UNITED STATES  
DEPARTMENT OF THE INTERIOR  
BUREAU OF LAND MANAGEMENT  
OCD HobbsFORM APPROVED  
OMB NO. 1004-0137  
Expires: January 31, 2018**SUNDRY NOTICES AND REPORTS ON WELLS**  
*Do not use this form for proposals to drill or to re-enter an abandoned well. Use form 3160-3 (APD) for such proposals.*5. Lease Serial No.  
NMLC030132B

8. Well Name and No.  
CLOSSON B 179. API Well No.  
30-025-08954-00-S110. Field and Pool or Exploratory Area  
JALMAT-TAN-YATES-7RVRS11. County or Parish, State  
LEA COUNTY, NM**SUBMIT IN TRIPLICATE - Other instructions on page 2**1. Type of Well  
☒ Oil Well ☐ Gas Well ☐ Other2. Name of Operator  
BREITBURN OPERATING LP  
Contact: SHELLY DOESCHER  
E-Mail: shelly\_doescher@yahoo.com3a. Address  
1401 MCKINNEY ST SUITE 1400  
HOUSTON, TX 770103b. Phone No. (include area code)  
Ph: 505-320-56824. Location of Well (Footage, Sec., T., R., M., or Survey Description)  
Sec 18 T22S R36E NWSW 1980FSL 660FWL**12. CHECK THE APPROPRIATE BOX(ES) TO INDICATE NATURE OF NOTICE, REPORT, OR OTHER DATA**

**Proposed Wellbore Diagram**

**Permanent Abandonment of Federal Wells  
Conditions of Approval (LPC Habitat)**

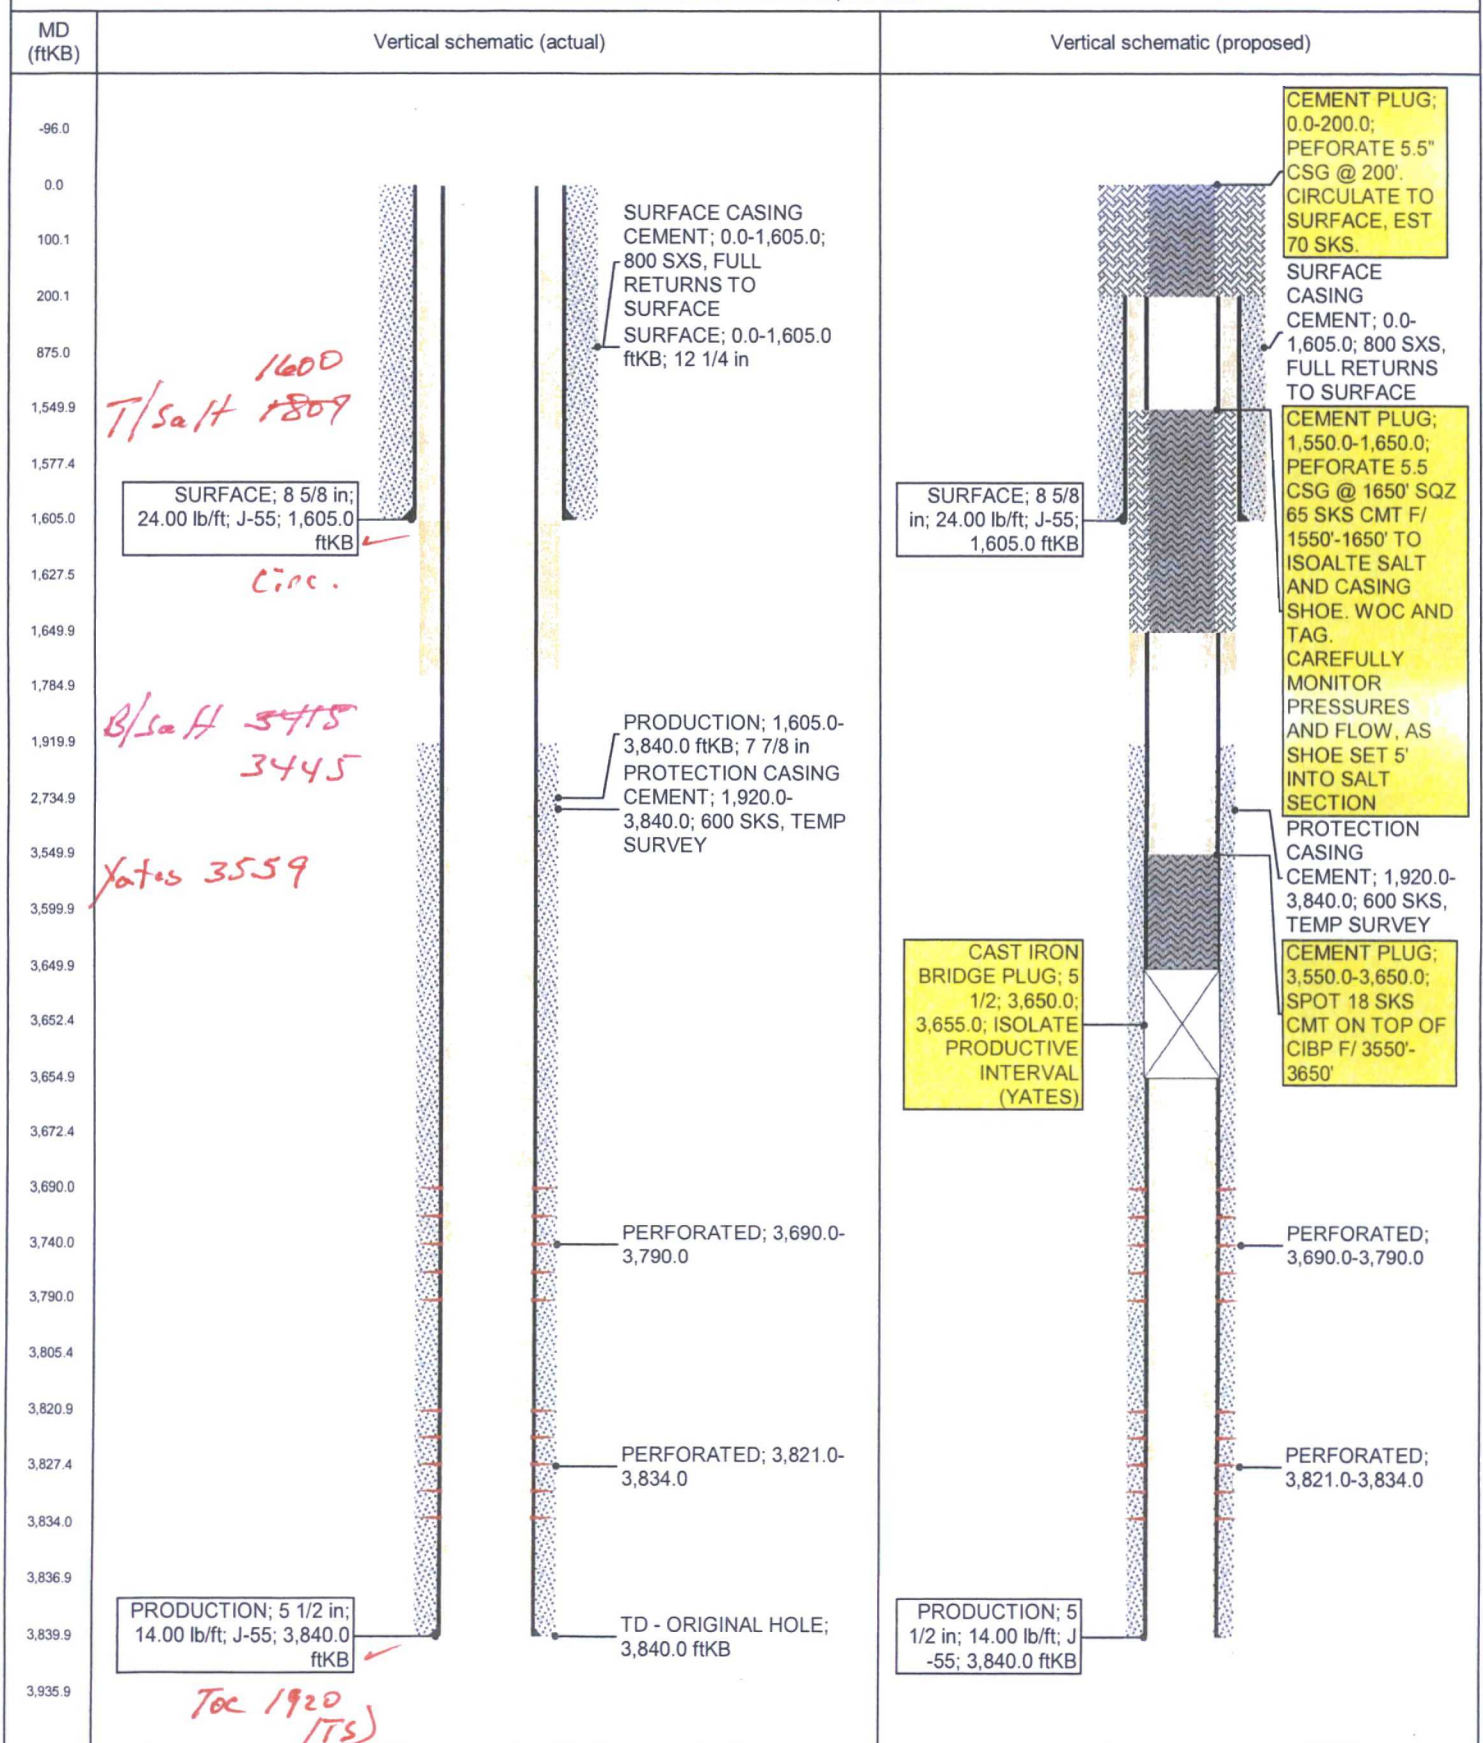
**\*\* BLM REVISED \*\* BLM REVISED \*\* BLM REVISED \*\* BLM REVISED \*\* BLM REVISED \*\*****FOR RECORD ONLY**  
NMCD 04/09/2018

(Consult with NMOCD on appropriate spacer, cement additives and procedure recommended by service company before beginning squeeze).
